Liddell Future Land Use and Enabling Works (SSD-24937520) – Muswellbrook Shire Council comments on Environmental Impact Statement

Reference is made to the *'Liddell Future Land Use and Enabling Works Environmental Impact Statement'* (GHD, March 2023) (EIS) and associated appendices.

Figure 3 – LPS Conceptual Landform (source: Rehabilitation Strategy)

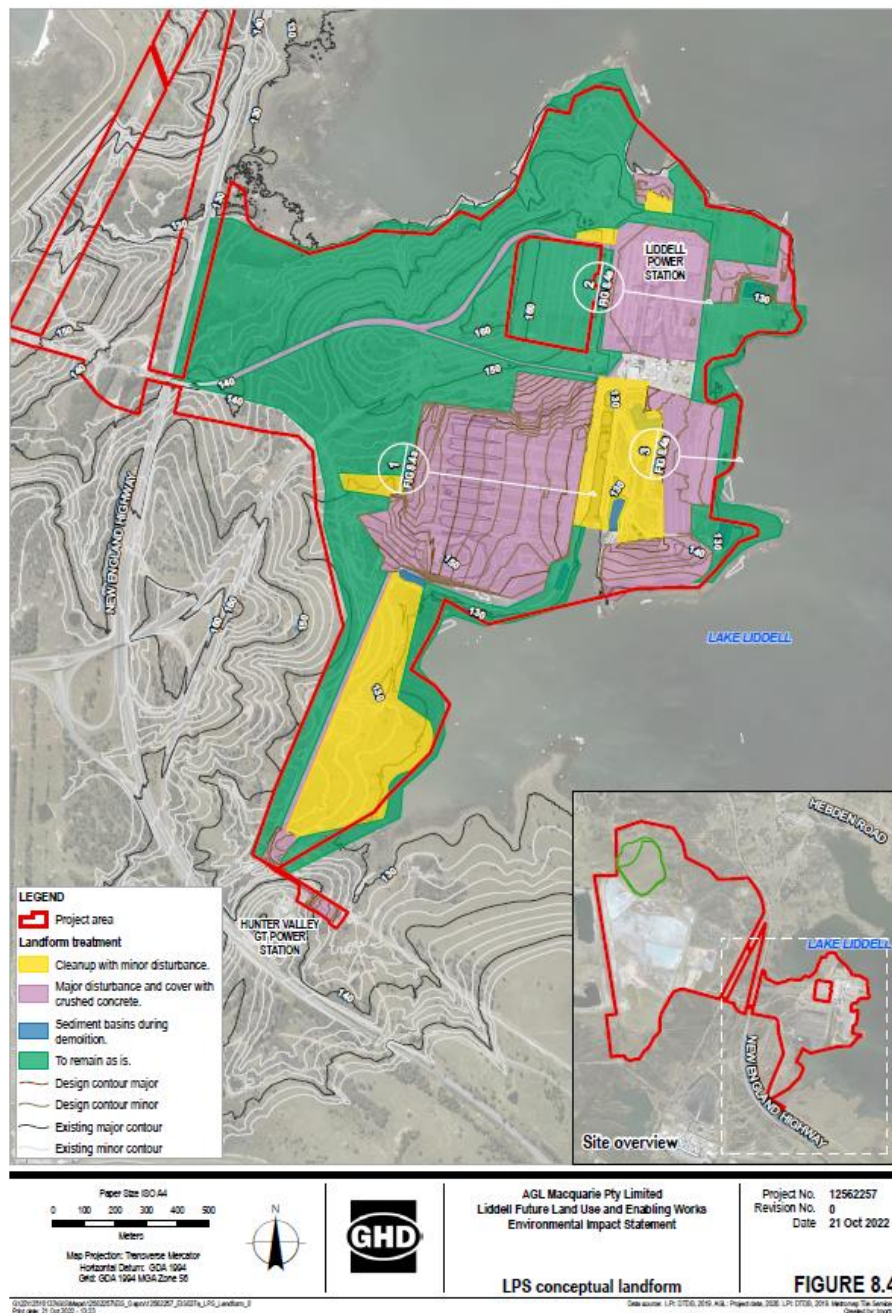
20. While the EIS makes reference to a Land Use Study, in particular a conceptual masterplan for the Liddell Core Investigation Area, the LPS Final Landform (Figure 3) and the Industrial Energy Hub, it would be expected that the EIS would contain a masterplan similar to that provided in Hunter Regional Plan 2041 (Figure 4) and also include a Project scale plan to generally show the location of areas proposed for employment generating activities and open space / biodiversity.

23. Most of the site (except for the borrow area) is a gentle slope. These areas will still require certain design principles (identified in the Rehabilitation Strategy) including a drainage design. The drainage design and final landform contours should be incorporated into site wide masterplan (see Ref 20)
24. As stated in the EIS, the final landform of the Borrow Area is required to have a maximum grade of 16.7% consistent with DA 2011-01.

The area that will be covered with crushed concrete is shown in by the pink polygon in Figure 3.

25. Council is concerned about the potential impacts of using concrete as substrate and require further information on how the following will be managed:
- a) Leaching of contaminants - Crushed concrete may contain contaminants such as heavy metals or residual chemicals from previous use or demolition. Over time, these contaminants can leach into the surrounding soil or groundwater, posing environmental risks.
 - b) Soil pH and nutrient imbalance - Crushed concrete may alter the pH and nutrient composition of the soil, affecting its fertility. This can require additional soil amendments and adjustments to maintain a suitable growing environment;

- c) Structural integrity - While crushed concrete can provide stability, over time it may experience settlement or uneven settling, leading to potential structural issues. Regular inspection and maintenance may be necessary to address any concerns.
- d) Limited permeability - Crushed concrete can have reduced permeability compared to natural soils, which may hinder water infiltration and drainage. This can result in poor water management, potential waterlogging, or increased runoff.
- e) Aesthetics and land use limitations - The use of crushed concrete as a substrate may not be visually appealing. Additionally, it may limit certain land use activities depending on the composition and condition of the substrate and make ongoing maintenance (e.g. site slashing) harder to achieve.

**Figure 4 – Liddell and Bayswater Power Station Proposed Growth Area
(source: Hunter Regional Plan 2041)**

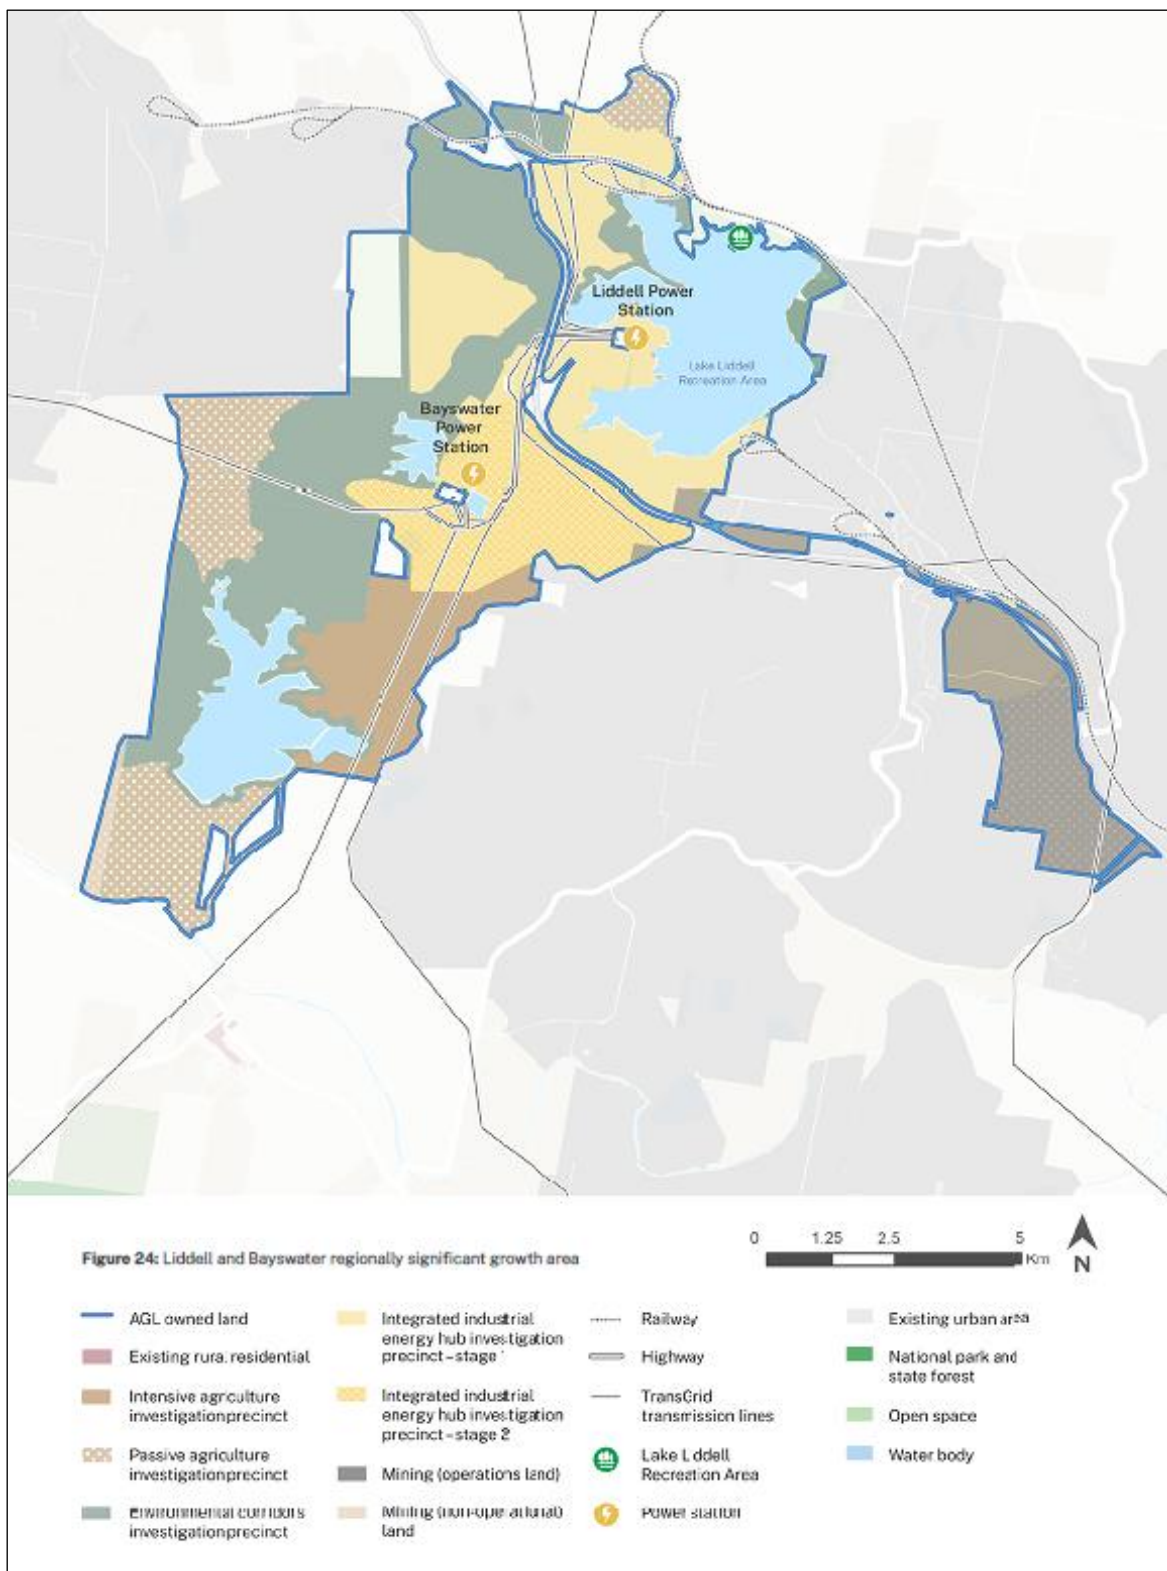
31. The embankment of the LAD can be seen in the view west toward the LAD (see Figure 6). The area between the LAD and the NEH has been identified as “environmental corridors investigation precinct” in the Hunter Regional Plan 2041 (HRP), see Figure 4. Council staff would prefer additional plantings in this area to soften the view toward the LAD embankment.

Figure 7 – View from the Liddell Recreation Area Looking West

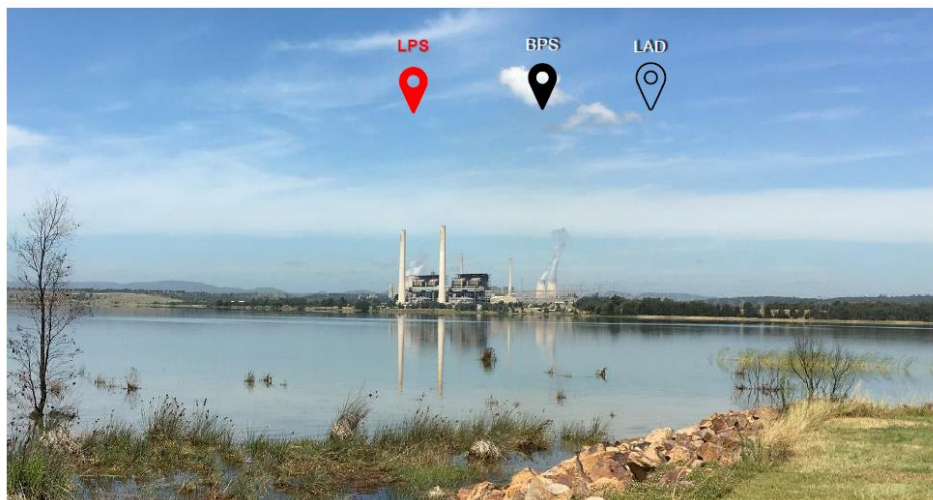
32. Views from Lake Liddell Recreation Area are shown in Figure 7. Council Staff would prefer additional / infill plantings to be undertaken on the eastern shore of the Project area, adjacent Lake Liddell, to improve future visual amenity of proposed industrial landscape.
